# Hybrids Phase III: Manual 10 and 14D Changes

System Operations Subcommittee  
May 29, 2025

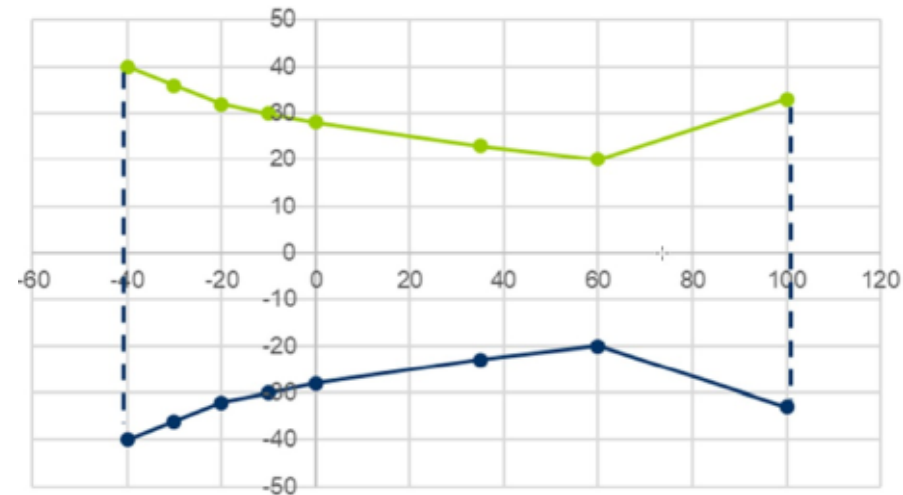
- Section 13.1 Marketing and Classification of Mixed Technology Facilities
  - Modified language to broaden eligibility to participate as a Hybrid Resource
  - Clarified classifications of open-loop and closed-loop based on definition changes
  - Updated language and diagram to be inclusive of all eligible resource types for hybrids
  - Updated language to specify when a Mixed Technology Facility must participate as a Hybrid Resource
  - Noted classification of closed-loop for any Hybrid Resource without storage component
  - Clarified that for all Mixed Technology Facilities participation change notifications must be made no later than six (6) months in advance of its initial start in the energy markets.
